Community and Economic Development

Planning Division

STAFF REPORT & RECOMMENDATION Harmony at Arlington Preliminary Major Unit Lot Subdivision Conditional Use Permit – PLN #1234

Regulating Plan Place Types

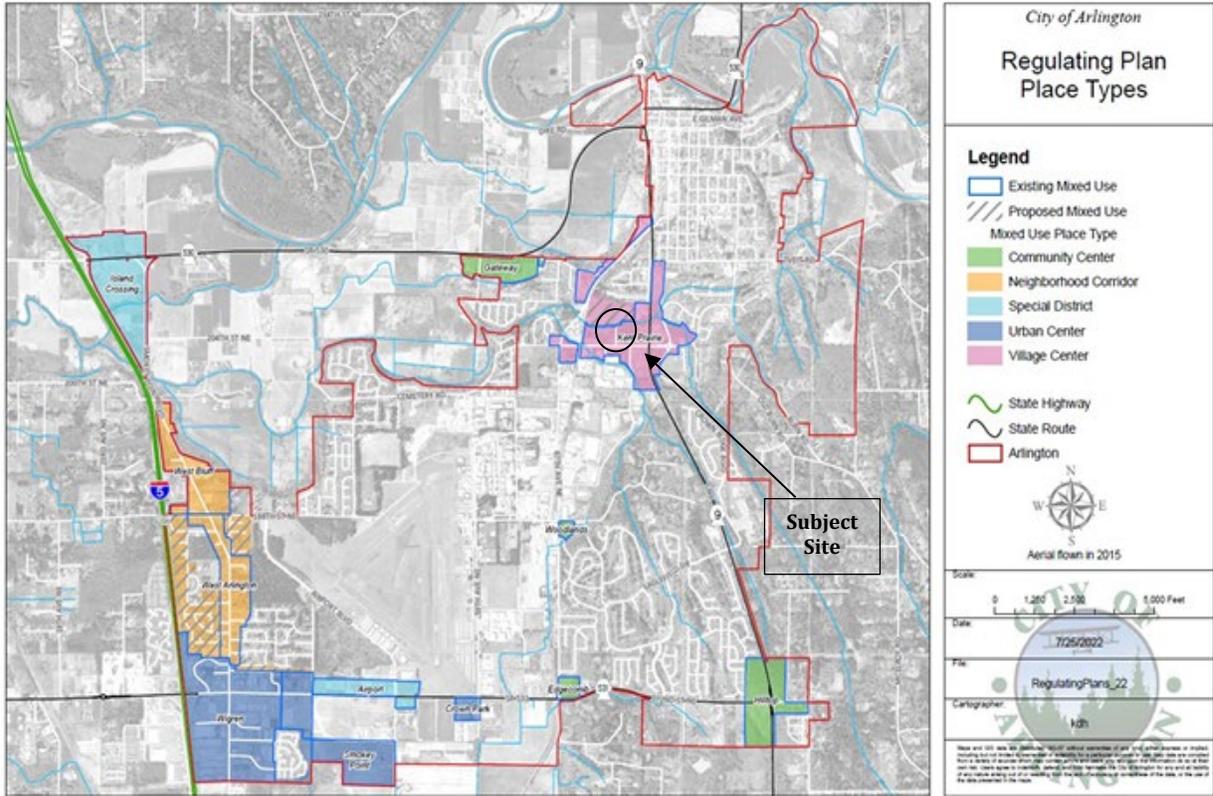
20.110.012 (e) Transect Summary.
 Zone – T4 Flex (T4-F).
Desired Form: Attached, Small to Large Footprint, Simple Wall Plane along Street, Building At ROW, Small to No Side Setbacks, Diverse Mix of Frontages, First Floor Flush with Sidewalk
General Use: Vertical and horizontal mixed use: retail, commercial, and residential uses on any floor. Ideal location for live/work conditions.
Intent: To provide an urban form that can accommodate a very diverse range of uses, including some light industrial to reinforce walkable neighborhoods and to provide a mix of uses on the ground floor, including residential, thus enabling the retail and service sectors to mature over time, while still allowing occupancy.

The proposed project is in the T4-F Transect of the Village Center Mixed-Use Development Regulations. The project provides medium footprint 3-story townhouses. The project provides a simple wall plane along the south and west portions of the property, as well as along the private drive aisle throughout the subdivision.
 The project is part of a horizontal mixed-use binding site plan with the commercial located south of the property on Tracts C and D.
 The project continues urban form in the area and is accommodating a diverse range of uses. The unit lot subdivision reinforces a walkable neighborhood to nearby commercial uses and provides residential uses on the ground floor.

Regulating Plan Place Type: Village Center

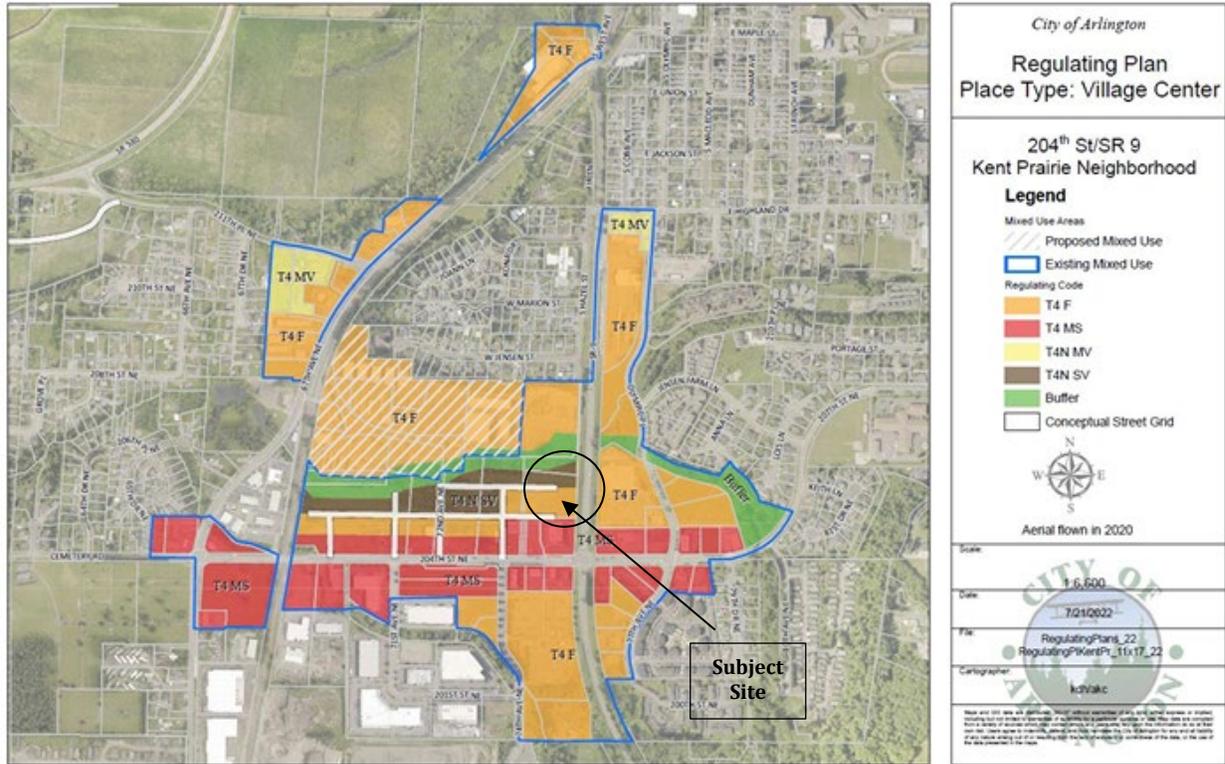
<p>20.110.014(c)(3) Place Types. Place Type: Mixed Use Village Center Location: State Route 9 and 204th Street, 204th Street and 67th Avenue, 211th Street and 67th Avenue. Use Intensity Transects: T4 Flex (T4-F)</p>	<p>The proposed development is located within the Mixed-Use Village Center. The project is located southwest of the 204th Street and State Route 9 Intersection and in the T4-F Transect.</p>	<p>Yes</p>
<p>20.110.014(c)(3) T4-F. Intent: To provide an appropriate transition from a neighborhood main street environment into the residential areas, and to provide flexible buildings that can allow a mix of residential and walkable local serving commercial and service uses. Key Features: Mix of medium density building types with a variety of forms which decrease in size and intensity of use toward the outer boundary of the center.</p>	<p>The proposed project provides the residential transitions from the existing commercial along the 204th Street frontage. The unit lot subdivision borders the Portage Creek stream buffer with a lower intensity than the commercial uses. The project provides medium footprint 3-story townhouses. The project is part of a horizontal mixed-use binding site plan with the commercial located south of the property on Tracts C and D and provides the transition to residential on Tract B to the natural setting and stream buffer on Tract A of the site.</p>	<p>Yes</p>
